Submissions on Environmental Assessment Report – Batch 1

March 2013

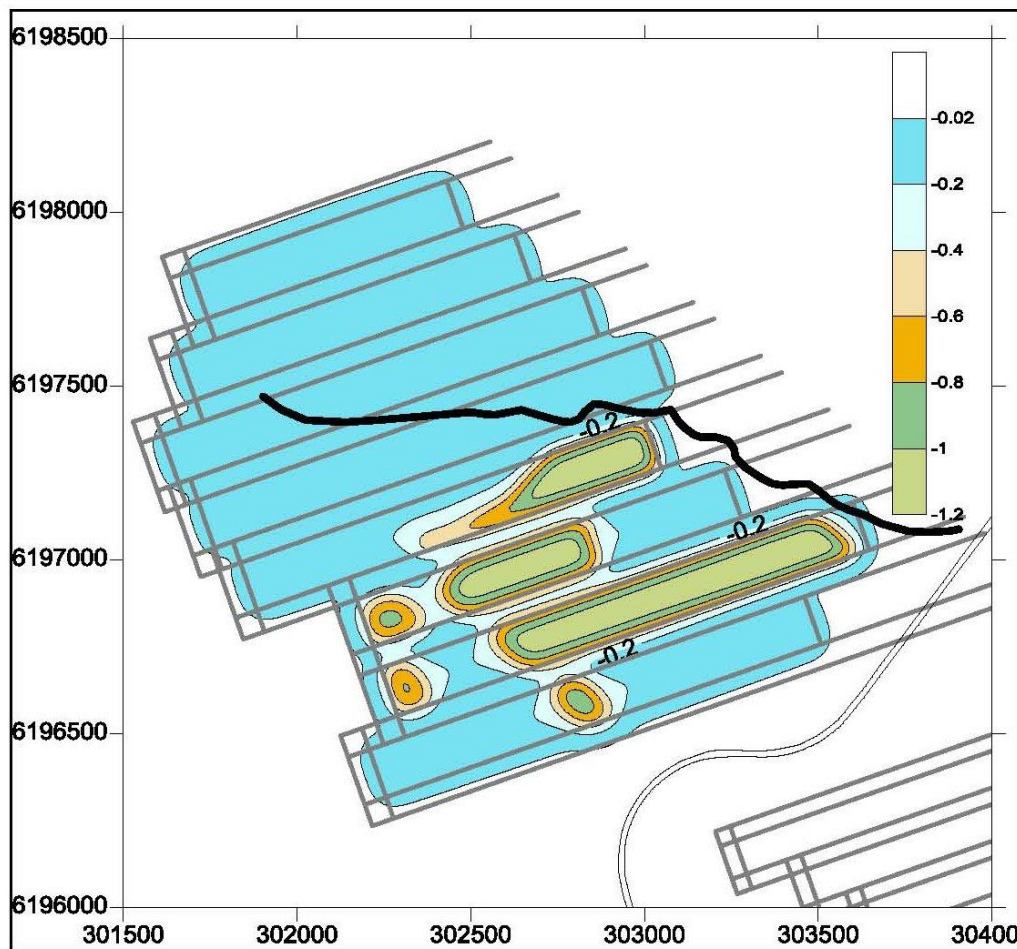
The longwalls 4 layout was curtailed to prevent impacts to Mt Ousley Rd. **Nonetheless longwall 4 did cause cracking on Mt Ousley Rd, even though it was some 300 metres away and outside the 35 degree angle of draw boundary.** Though the cracking was minor, this further demonstrates the uncertainty of subsidence prediction and the uncertainty of triple seam mining.

In a July 2012 Seedsman reported a revision of the predicted maximum subsidence for LW4 to 1.2 metres, with parameters adjusted in accordance with the observed subsidence to October 2012. This revision was made publically available as part of the EA documentation for the current project proposal and is used to provide new ‘visualisations’ of the SPDS modelling for remaining longwalls in the Wongawilli East domain.

Longwalls that follow the first of a series behave differently to the first and will reactivate the subsidence of preceding longwalls. **There is no reason to assume that the post-LW4 revised SPDS modelling will be any more accurate than the pre-mining modelling for LW4 in predicting the extent of vertical subsidence arising from the new longwalls.**

Figure 2. MSEC[2] depiction of fracture zone height with respect to panel width from Attachment A to the BHP-Billiton Dendrobium Area 3B SMP documentation.

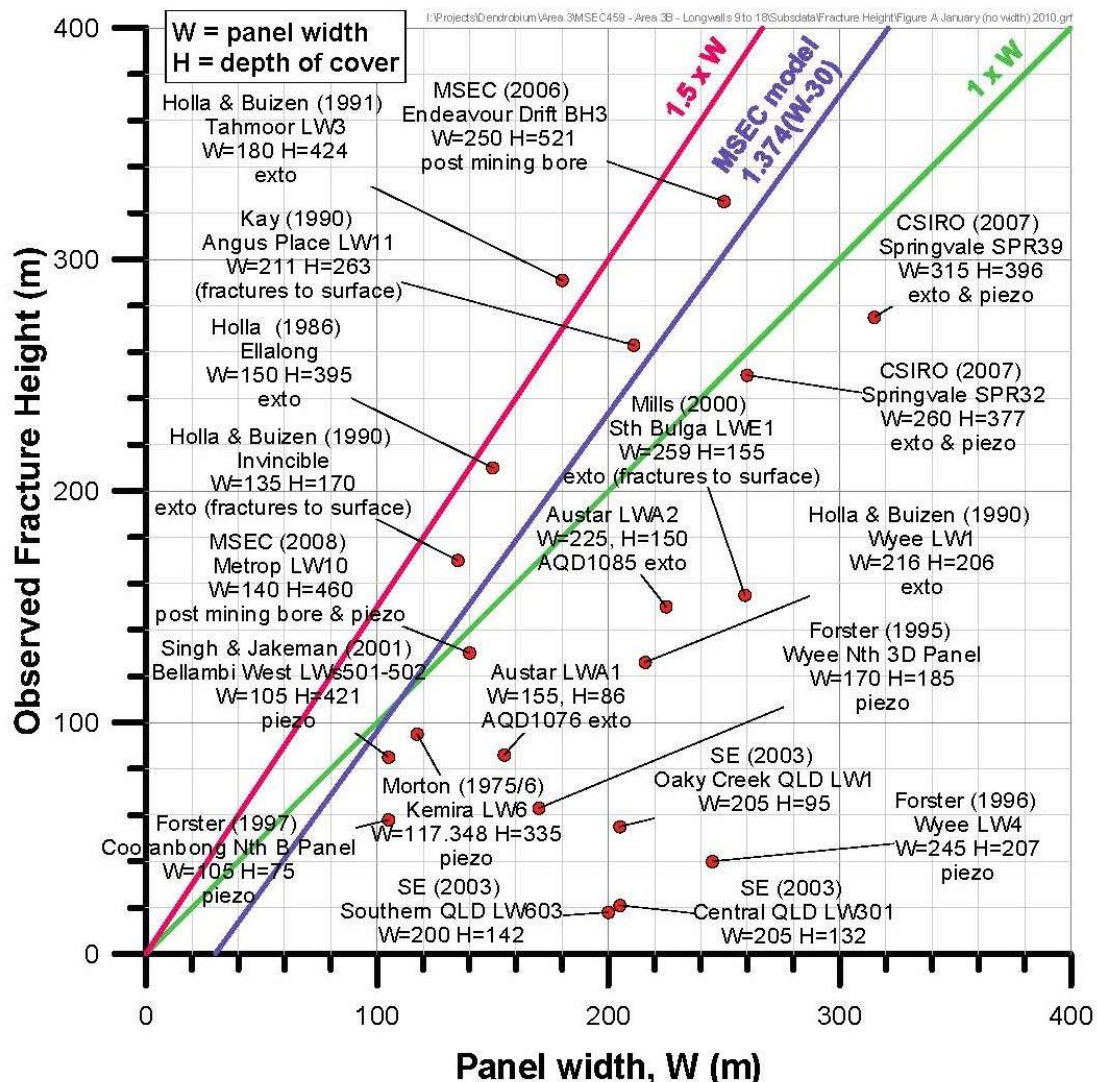
With respect to the last point, the average depth of cover for the domains of the BSO project ranged from 400 m to 600 m, so the Bald Hill Claystone layer would in general have been just beyond the fracture ‘horizon’ expected at 1 to 1.5 times the panel width. The Panel comments “In the opinion of the Panel there is substantial uncertainty about the magnitude of the subsidence-related impacts, particularly in areas where the depth of cover is approaching the predicted height of fracturing (i.e. 385 m) for 310 m longwalls.” That is, **the predicted height of fracturing is 1.25 times the panel width.**

The expectation is then that, depending on the local geology, **the collapsed zone may extend between 1 to 1.5 times the longwall panel width.** MSEC reaffirm[this assessment in their 2012

subsidence prediction report for BHP-B's Subsidence Management Plan for Dendrobium Area 3B (see Fig. 2). This is also reflected in Coffey Geotechnic's groundwater modelling for BHP-B's Subsidence Management Plan for Dendrobium Area 3B (e.g. Figs. 3 and 4). Both MSEC[2] and Coffey[3] indicate that in some locations the collapsed zone above the 310 metre wide longwalls will reach into the Bald Hill Claystone and may extend to the surface. MSEC conservatively comment *"The depth of cover directly above the proposed longwalls varies between 310 metres and 450 metres and, therefore, it is possible that the fractured zone could extend up to the surface, where the depths of cover are the shallowest."*

Figure 3. Coffey depiction of collapsed zone above Dendrobium Longwalls 3, 4 and 5; from Attachment C to the BHP-Billiton Dendrobium Area 3B SMP documentation.[3]

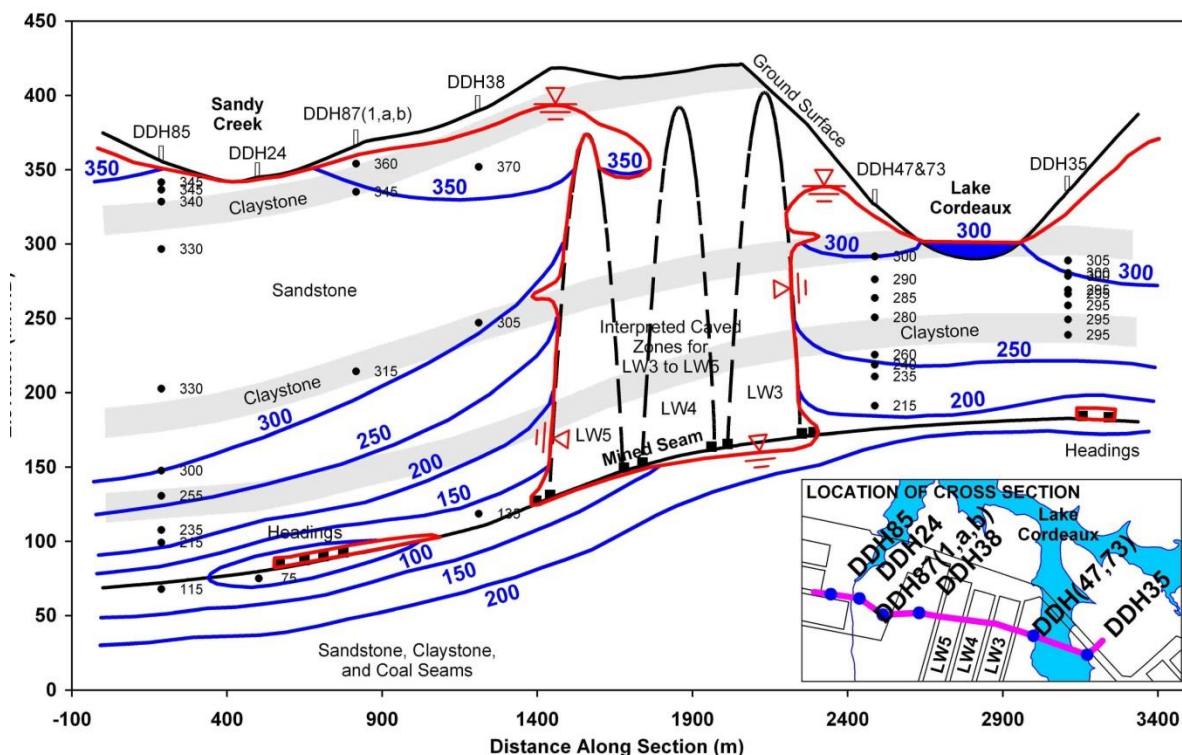
GeoTerra indicate the 501 to 509 panels in the Wonga West domain were 110 metres wide and that interconnected fracturing extended to 153 metres, with increased permeability extending into the middle Bulgo of the Bulgo sandstone as a result of delamination. These narrow longwalls also lowered the Hawkesbury Sandstone water level by some 10 to 15 metres. GeoTerra report that a piezometer (P5) installed in the Bulgo Sandstone, 226 metres below the surface, showed a drop of 15 to 20 metres following the passage of the longwall below. The piezometer shows a response to rain that GeoTerra explain as a response to *"recharge and infiltration into the cracked overburden"*. That is, **the response is consistent with increased permeability reaching the surface as a result of subsidence.**

The proposed 390 metre longwalls may reasonably be expected to have a collapsed-zone of 390 to 585 metres above the mined seam, where the depth of cover ranges from 455m to 510m. Even if the collapsed-zone extends no further than the Bald Hill Claystone, this has significant implications for groundwater flows and water loss from the local area catchment.

RECOMMENDATION 3: Given the sensitivity of the Special Areas single seam longwall and pillar widths should be within the limits of the Reynolds recommendations. Multi-seam layouts should be more conservative.

Figure 5. Record of water inflow to the Dendrobium Mine to June 2012 (from Attachment C of the Dendrobium Area 3B SMP documentation).

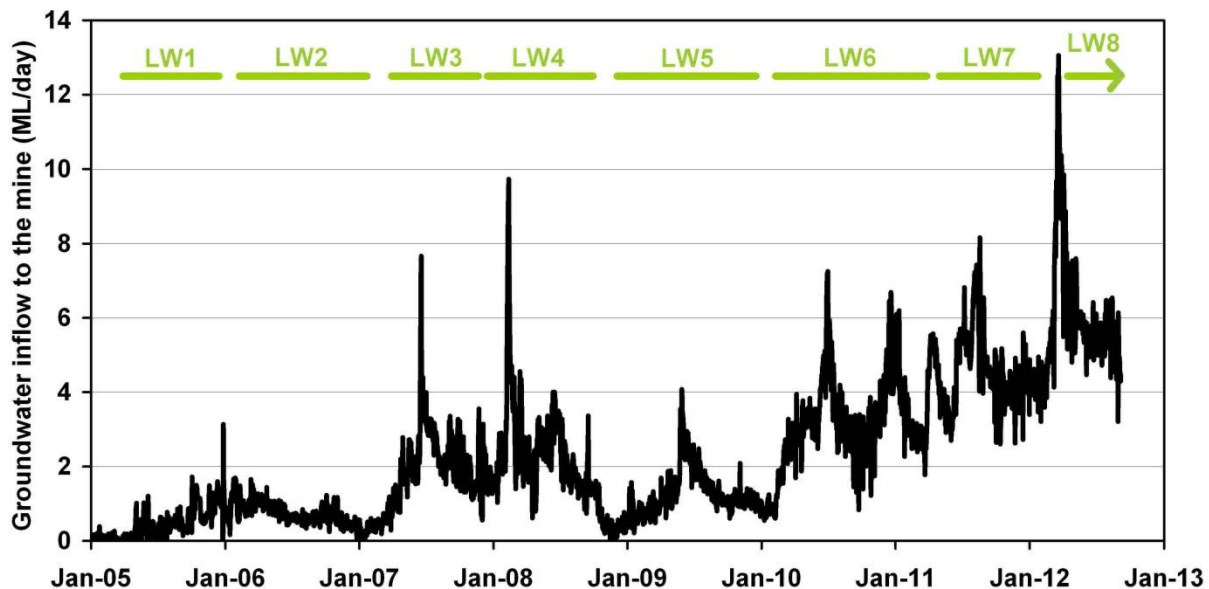
Of relevance, the Dendrobium mine has a history of high water inflows (Figure 5), with notably large inflows into Area 2 in June 2007 (peaking at 7.5 ML/day) and February 2008 (peaking at 9.5 ML/day), and into Area 3A in June 2010 (7.2 ML/day) and December 2010 (6.7 ML/day).[5] **A particularly large inflow event occurred in Area 3A in 2012, peaking at 13 ML/day and this would appear to be associated with the 305 metre wide longwall 8.**

Figure 6. Shallow groundwater piezometer (blue line) readings before during and after mining of longwall 5 in Dendrobium Area 2. The piezometer stops responding to rain as a result of mining, with the water level dropping.

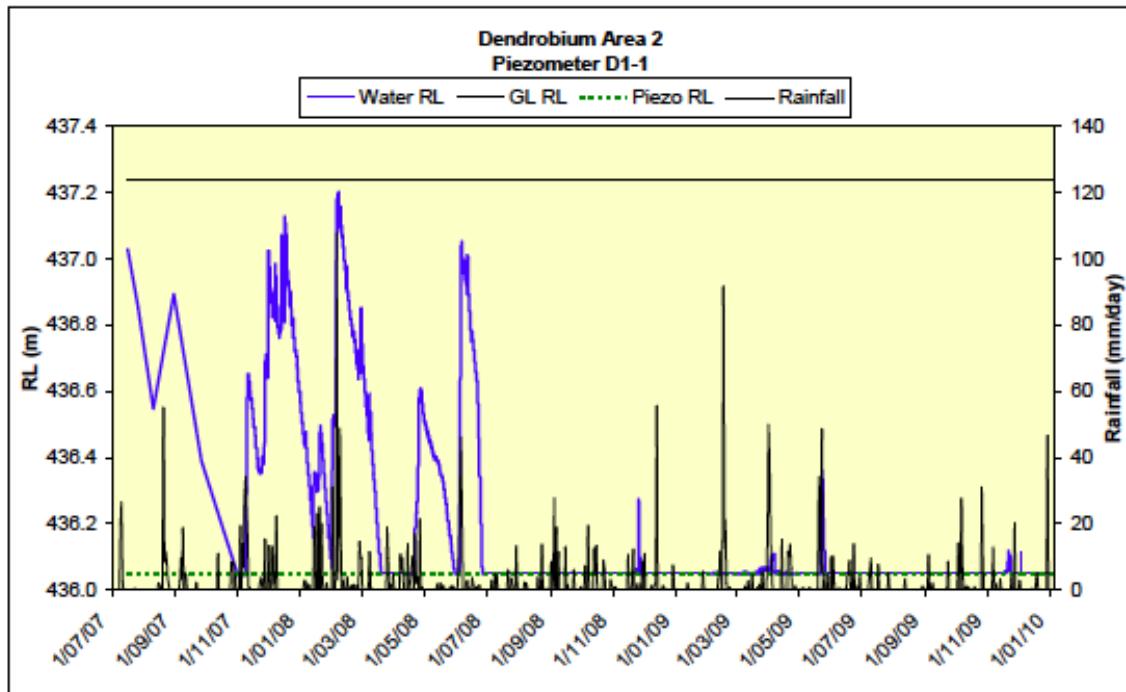
Swamp 1 over longwall 5 of BHP-Billiton's Dendrobium Mine. Figure 6 shows the piezometer trace and Figure 7 and 8 show the associated swamp damage.

There is a **very significant difference** between the level 3 hydrology trigger for LW5 and the determination that a negative environmental outcome has occurred when *there is a significant decrease in water levels within the swamp that is directly attributable to subsidence.* The LW5 level 3 trigger does not, in any sense, provide a warning that would allow a timely response that would prevent negative outcomes. **That is, the LW5 trigger is inadequate.**

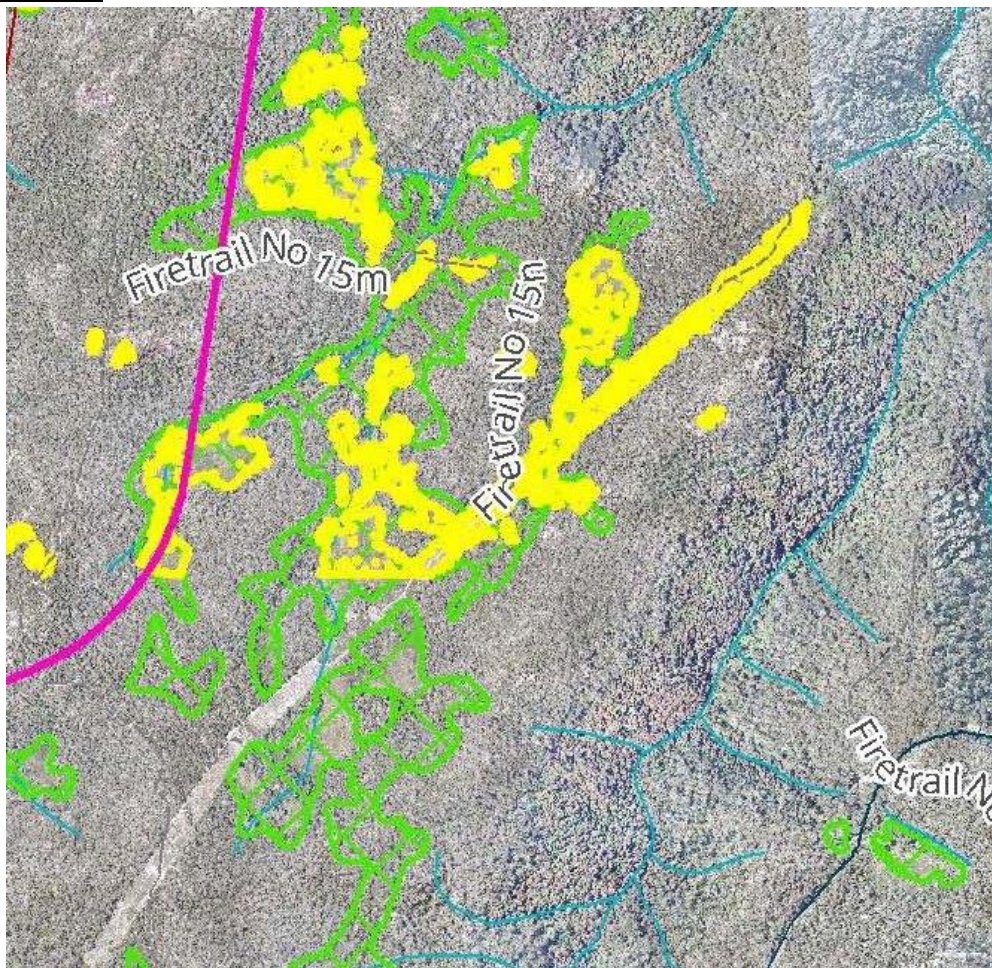
Unfortunately Seedsman don't identify the swamps and their observations don't seem to be reflected in the Biosis report provided as Annex Q. In considering mine impacts, it may be significant that Biosis report that the swamps in the Wonga West area are generally larger and more spatially continuous, whilst those in the Wonga East area are generally drier, shallower and less spatially continuous.

A comparison of Table 4 and Table 5 in Annex Q shows that the area of the swamps in Wonga East as mapped by NPWS in 2003 is 68.04 ha, in contrast to 49.06 ha mapped by Biosis in 2012. This may reflect the different mapping techniques and climate effects, but may also **reflect real boundary changes in response to the mine below**. As Fig. 9 shows, there are significant boundary differences for the swamps over the Elouera workings.

Map from Annexure Q – Biosis -Upland swamp assessment

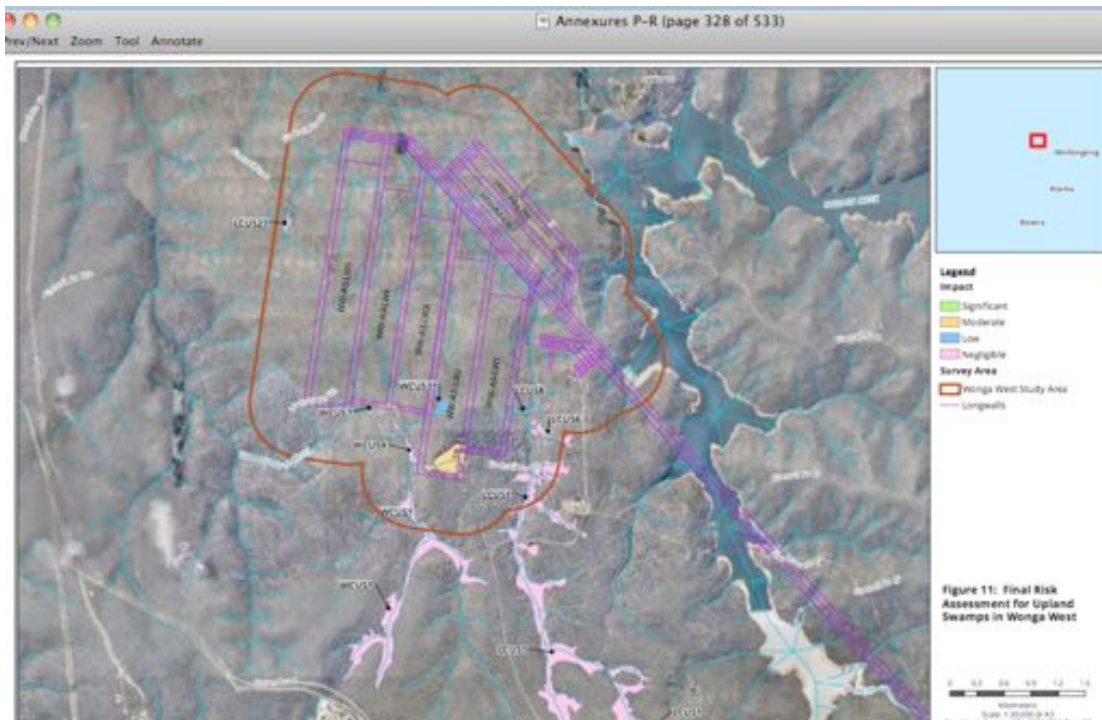
We suggest that a quick look at the Biosis map (below), “Figure 11: Final Risk Assessment for Upland Swamps in Wonga West” gives a false impression as many swamps are not shown on the map. The Geoterra map (above) gives a quite different impression of the number of swamps in Wonga West which will be impacted.
